Access Compliance Report

Public Rights-of-Way

(Curb Ramps)

Intersection ID: 30544	Main Street: STONECROFT_PARK_DR	Cross Street: SUMMERHILL_RIDGE_DR	Location: SE
ADA ID: 874AEFA13069	Ramp Type: PerpDiag	Initial Pass/Fail: Fail	Overall Compliance: No
Severity Score: 21.25			
Codes/Mitigation Info/Possible Solution		Field Measurements/Component Compliance

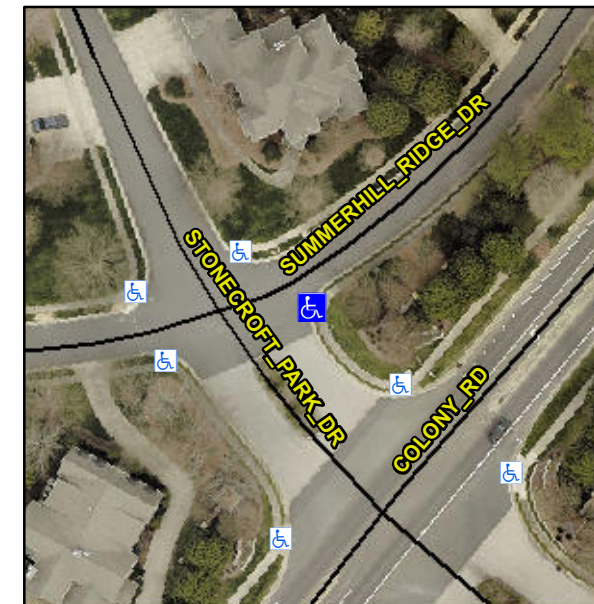
Not Found, R304.5.1, R304.5.3

Compliance	Description	Data	Compliance	Description	Data
N/A	Ramp Length (in)	72.0	Yes	Ramp Slope (%)	6.1
No	Ramp Width (in)	41.0	No	Ramp XSlope (%)	6.3
N/A	Flare Type LT	N/A	N/A	Flare Type RT	N/A
N/A	Flare Slope LT (%)	N/A	N/A	Flare Slope RT (%)	N/A
N/A	Flare Traversable LT?	N/A	N/A	Flare Traversable RT?	N/A
N/A	Landing Length (in)	N/A	N/A	DWS Provided?	N/A
N/A	Landing Width (in)	N/A	N/A	DWS Contrast?	N/A
N/A	Landing Slope (%)	N/A	N/A	DWS Length (in)	N/A
N/A	Landing X Slope (%)	N/A	N/A	DWS Full Width?	N/A
N/A	Landing Curb? (Y/N)	N/A	N/A	DWS Offset (in)	N/A
N/A	Shared Landing?	N/A			
N/A	Gutter Ponding?	N/A	N/A	Gutter Slope (%)	N/A
N/A	Gutter Lip Ht (in)	N/A	N/A	Gutter X Slope (%)	N/A
N/A	Painted X Walk1?	No	N/A	Painted X Walk2?	No
	X Walk 1 Direction	To NW		X Walk 2 Direction	To SW
N/A	X Walk 1 Width (in)	N/A	N/A	X Walk 2 Width (in)	N/A
	X Walk 1 Slope (%)	1.3		X Walk 2 Slope (%)	8.7
	X Walk 1 X Slope (%)	7.3		X Walk 2 X Slope (%)	2.4

N/A	Ramp inside XWalk1?	N/A	N/A	Ramp inside XWalk2?	N/A
	Road Slope (%)	7.5	N/A	Clear Space?	N/A
	Road X Slope (%)	5.3	N/A	Clear Space to XWalk (in)	N/A
N/A	Any Obstructions?	N/A	N/A	Storm Grate/Utility Hazard?	N/A
	Obstruction Type			Storm Grate/Utility Type	
		N/A			N/A
			Yes	Surface Condition? (G/P)	Good

Remove & Replace Curb Ramp With Two New Directional Ramps or Equivalent.
